DOCUMENT 009113 - ADDENDA

- A. Addendum No. Two.

- A. Project Name: Skatium Locker Room Renovation.
- B. Owner: Township of Haverford.
- C. Owner's Representative: C.B. Development Services, Inc.
- D. Architect: BKP Architects.
- E. Date of Addendum: October 4, 2024

Skatium Locker Room Renovation
Responses to Bidder Questions and Written Identification of Modifications to Project Documents

A10 | **CHANGE ROOM PLAN**
1/4"=1'-0"

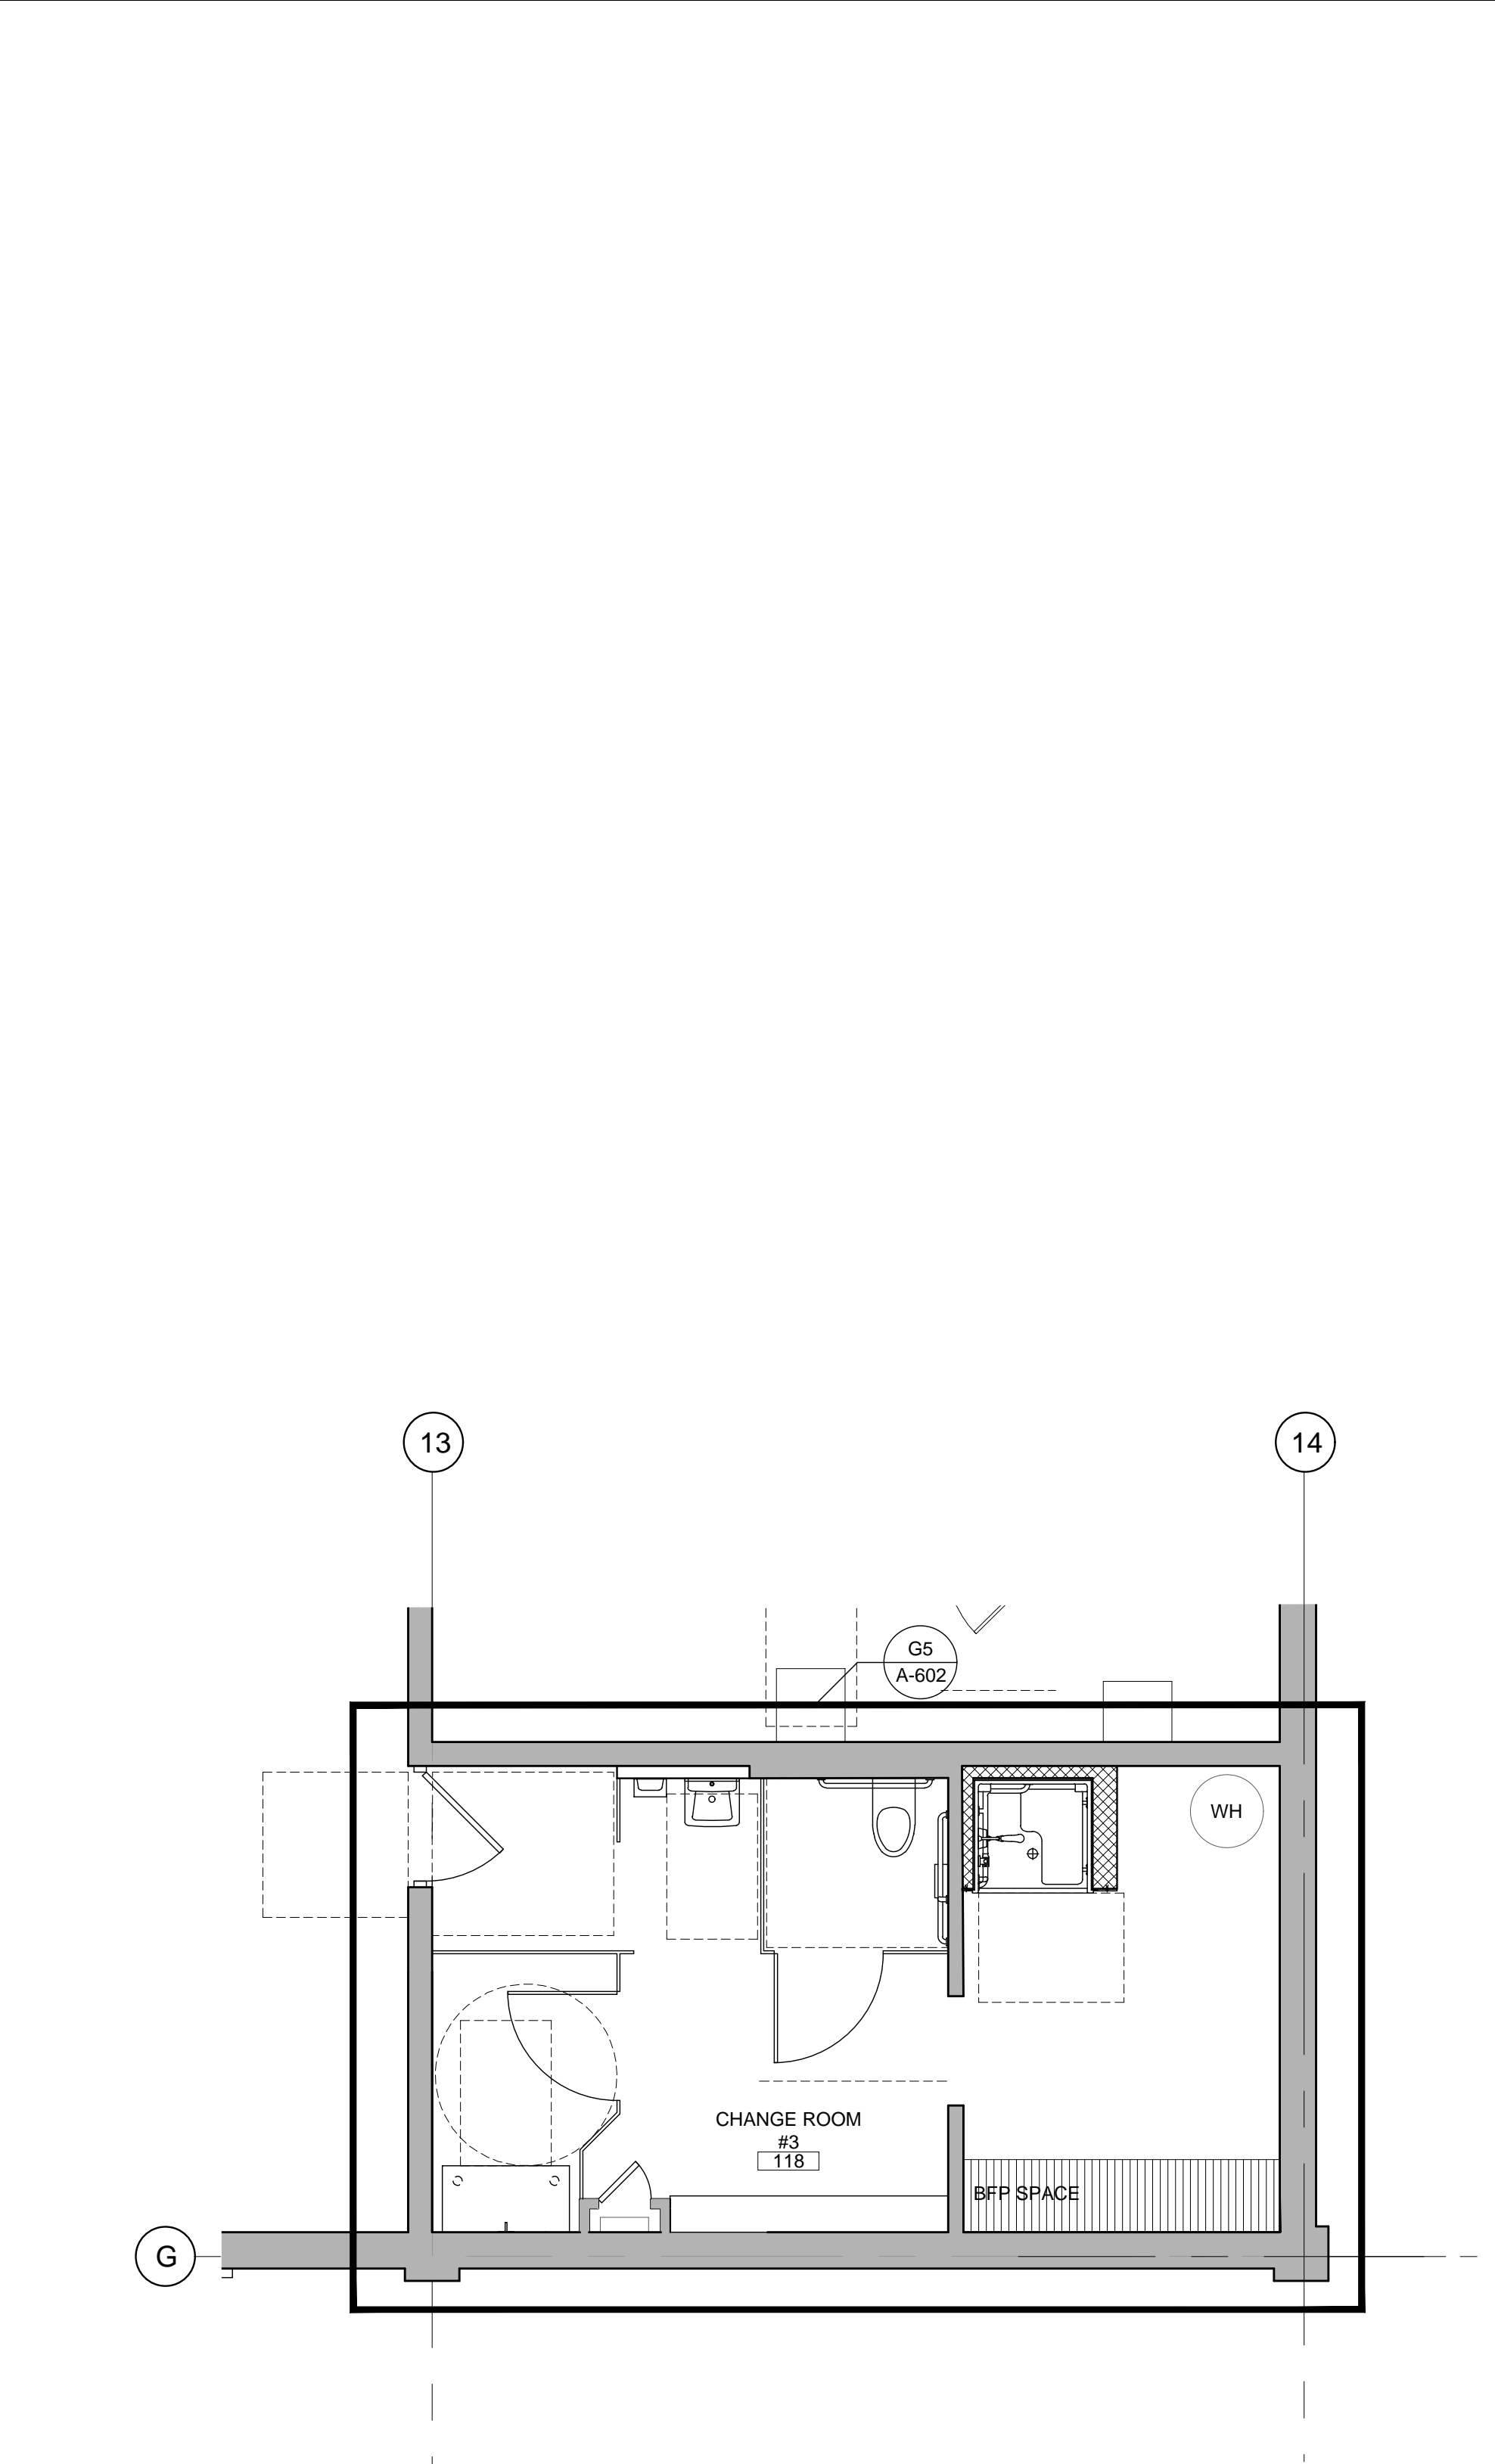
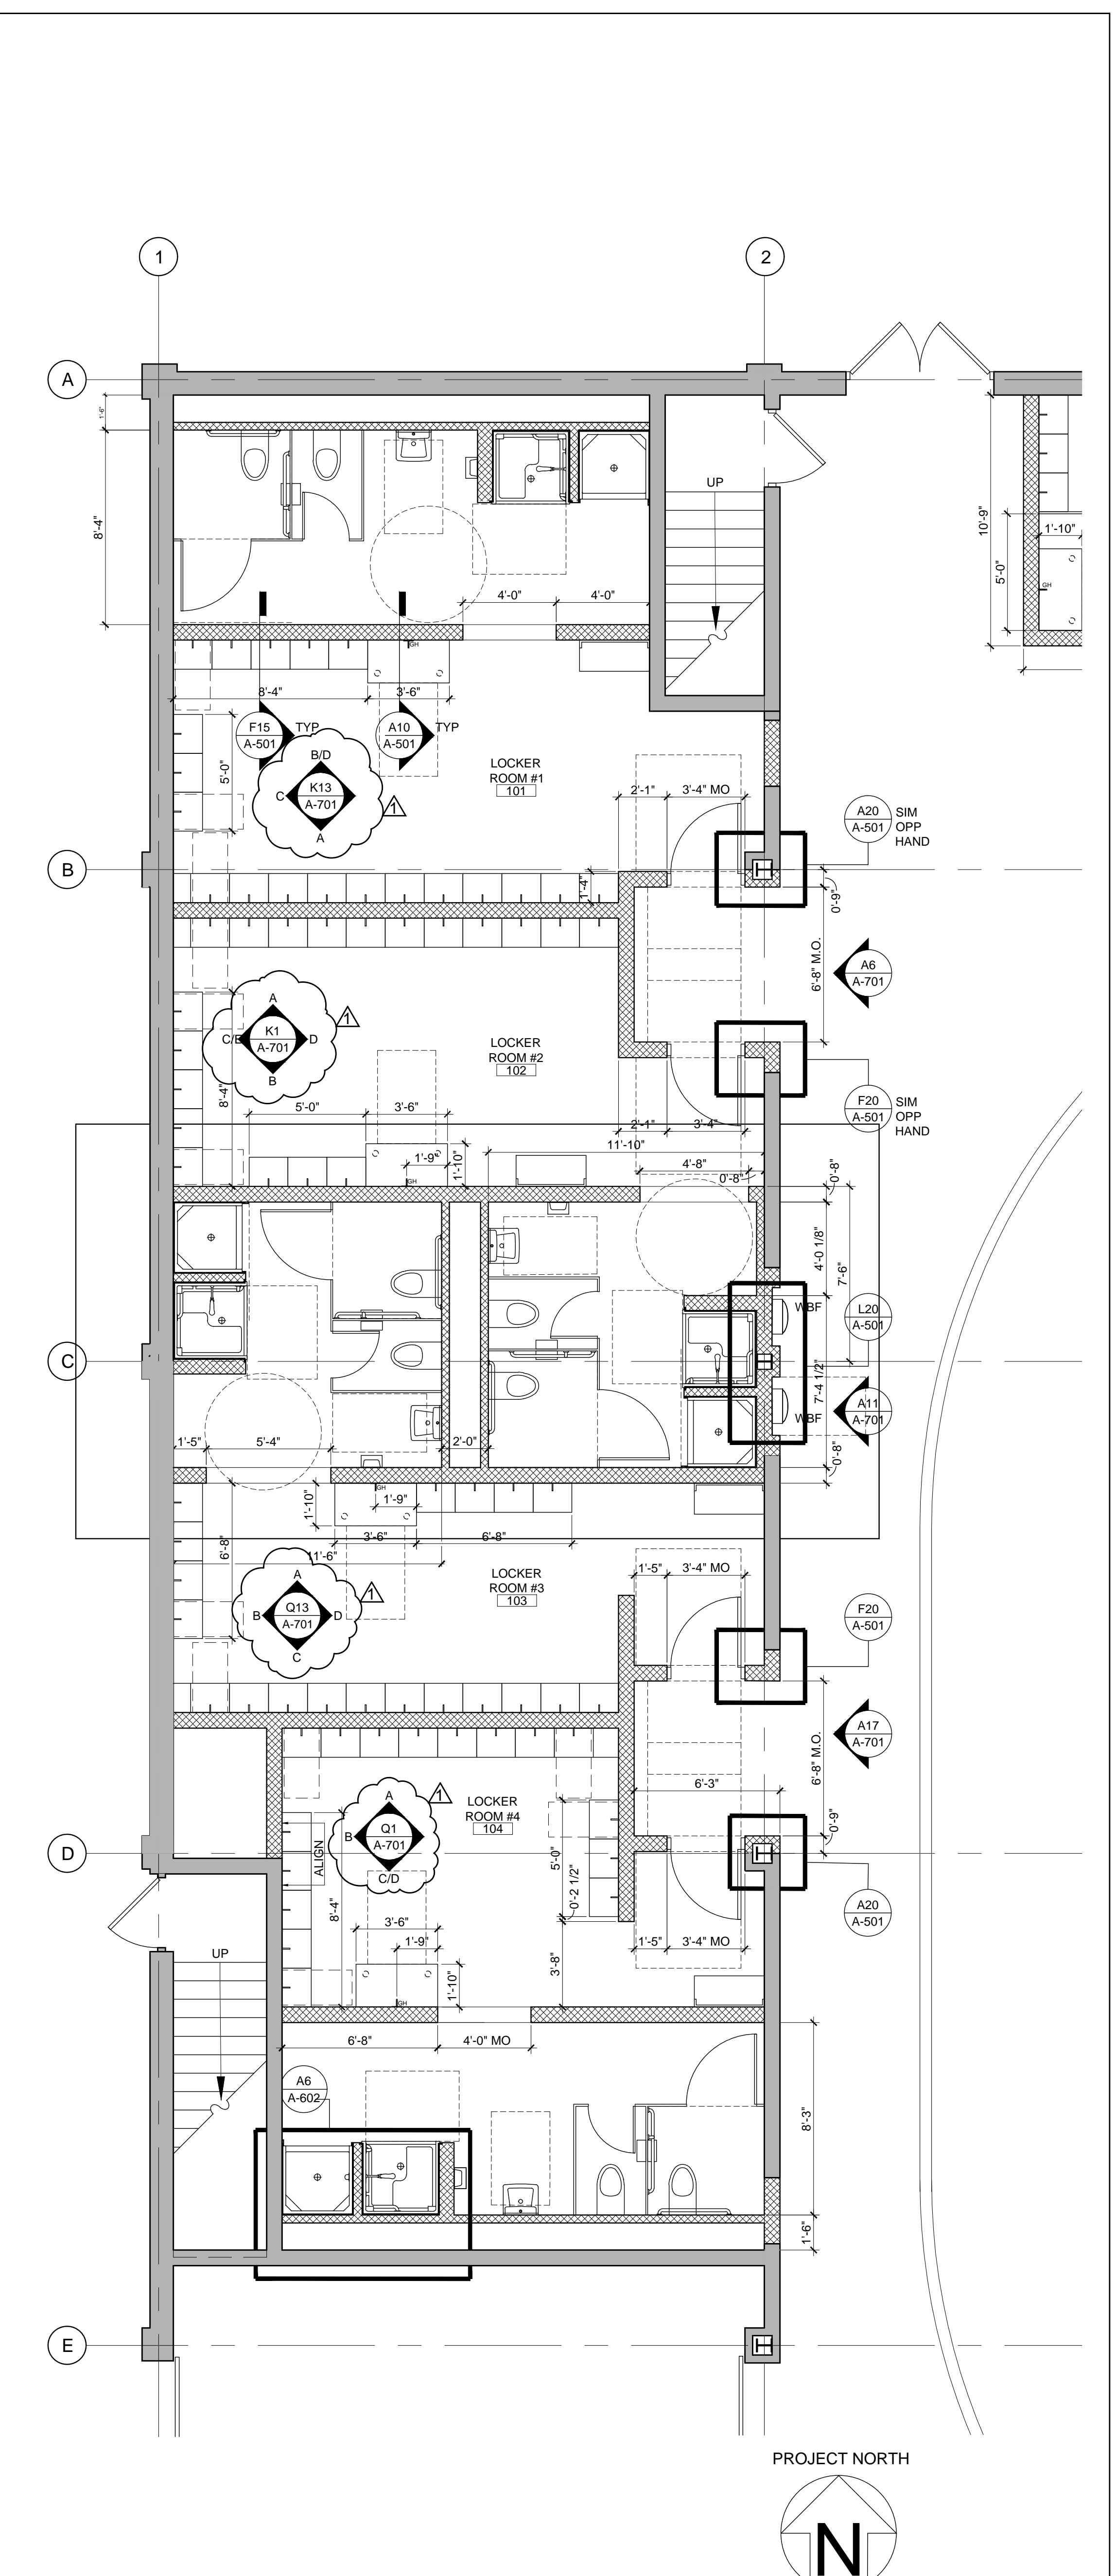
8. Several sheets reference Sheet A-100 which does not exist. Please advise.

- I. Drawing A-101 has been modified to include missing door hardware sets.
- J. Drawing A-601 has been modified, removing references to Sheet A-100, replaced with reference to Sheet A-701.

Reference to Sheet A-100 should have been A-701. Drawing sheets A-601 and A-602, which are affected by this change have been revised and issued with Addendum #2.
